# Supporting contribution to comments regarding error ratio allocation in optical PMD clauses

Huawei Technologies Co., Ltd

- Clarification in the draft is suggested regarding error ratio allocation for IMDD optical PMDs.

Figure 176B-2—xBASE-R PHYs with one and two physically instantiated interfaces

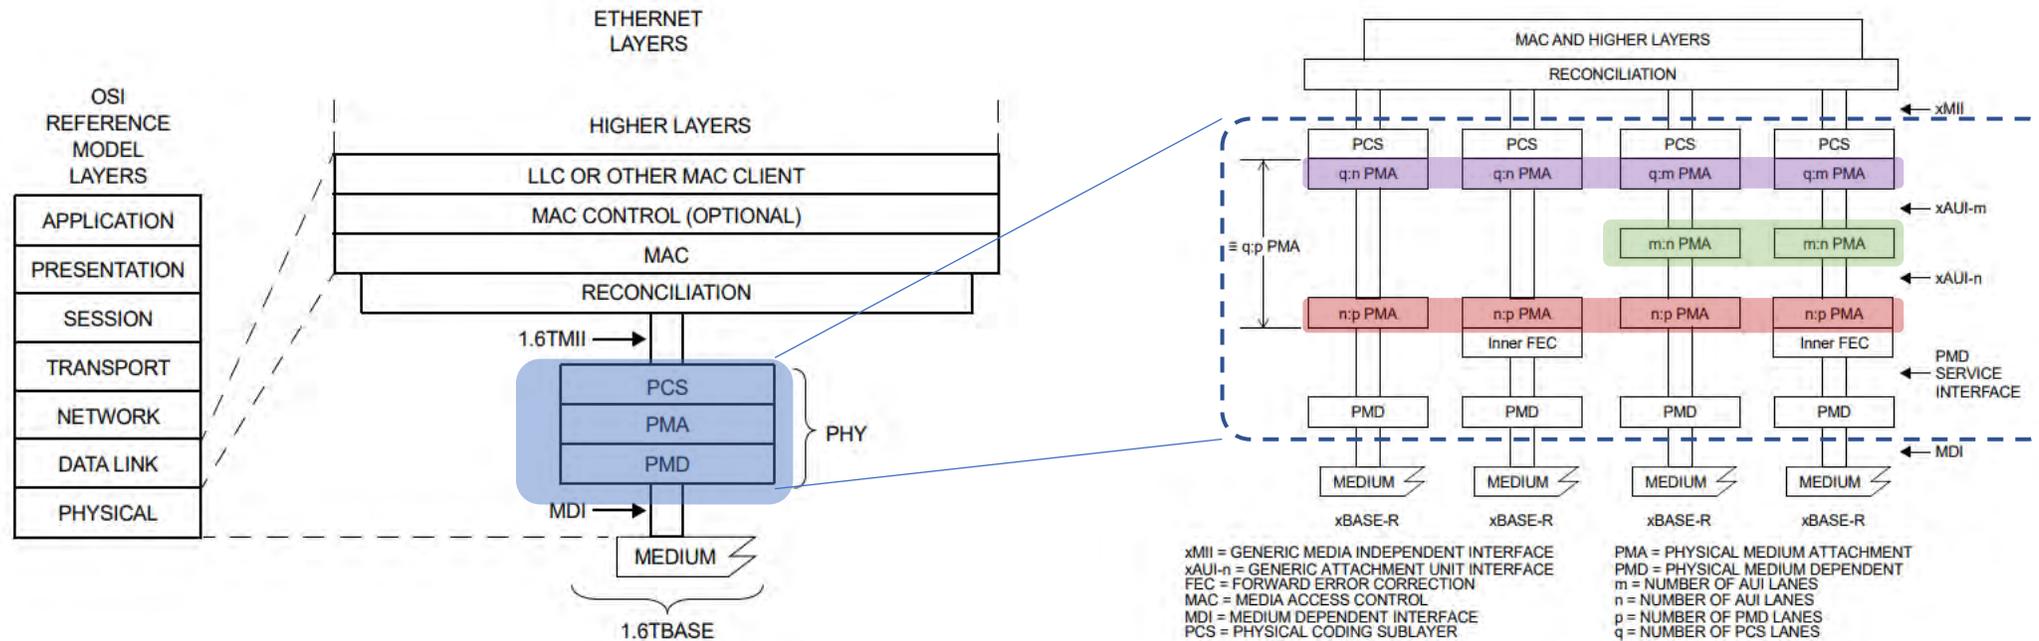
1. Immediately before (transmit direction) and after (receive direction) PMD service interface (no AUI included) ← Error ratio
2. In between xAUI-n and xAUI-m (including only the AUI C2Ms)
3. Immediately after PCS (including all AUI interfaces that the data stream will pass)

Measured between the two PMAs immediately adjacent to the PMD in both the transmit and receive direction.

Referencing to Figure 176B-2 will be helpful too.

Table 174A-1—Error ratio allocations for optical PHYs

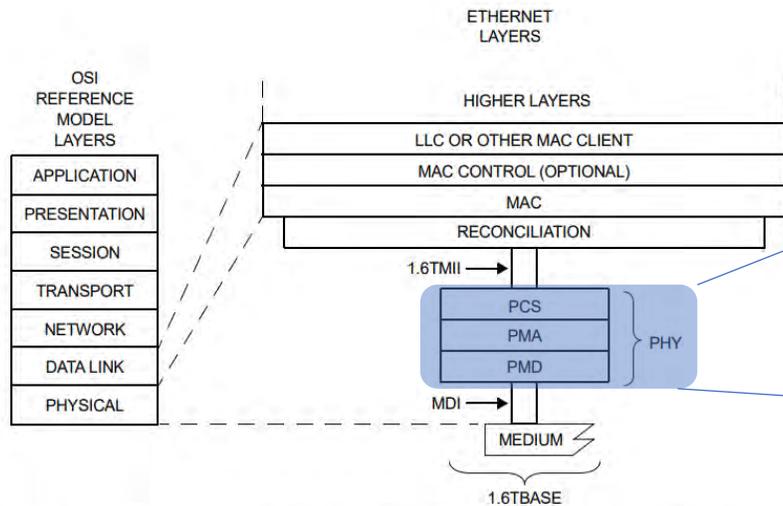
PMA: BER<sub>added</sub> = xAUI-n C2C + xAUI-n C2M + xAUI-n C2M + xAUI-n C2C ← Clarified with the previous section

PCS: BER<sub>added</sub> = xAUI-n C2C + xAUI-n C2M ← Guessed from the number

Figure 176B-2—xBASE-R PHYs with one and two physically instantiated interfaces

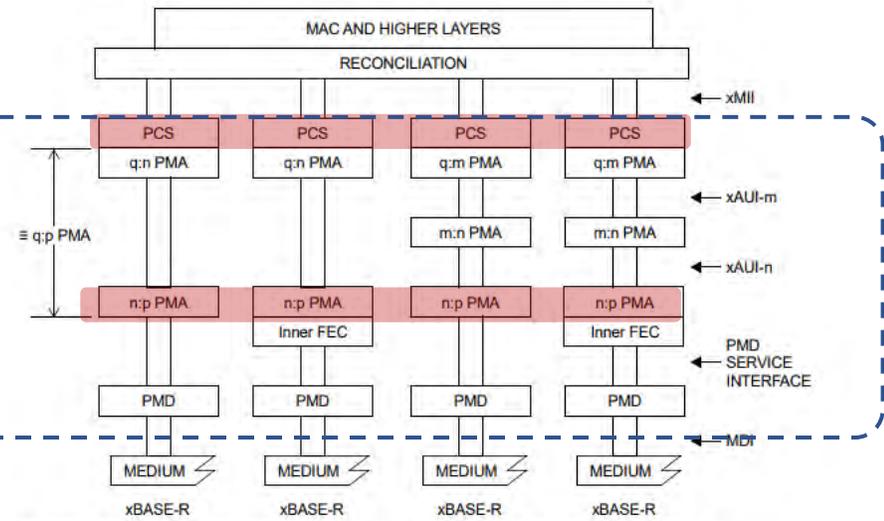
Error Ratio considered at PCS is measured with contribution of AUIs, with two possible variations on where transmit starts:

Clarification?

Scrambled Idle transmitted from	AUI instantiation passed when Received at PCS
PMA immediately above the PMD service interface	Max. 2 AUI instantiation, depending on test fixtures.
PCS	Max. 4 AUI instantiation. Depending on test fixtures.

Author's view: pessimistic option may be the easier choice to unify all variations of test fixture and equipments.
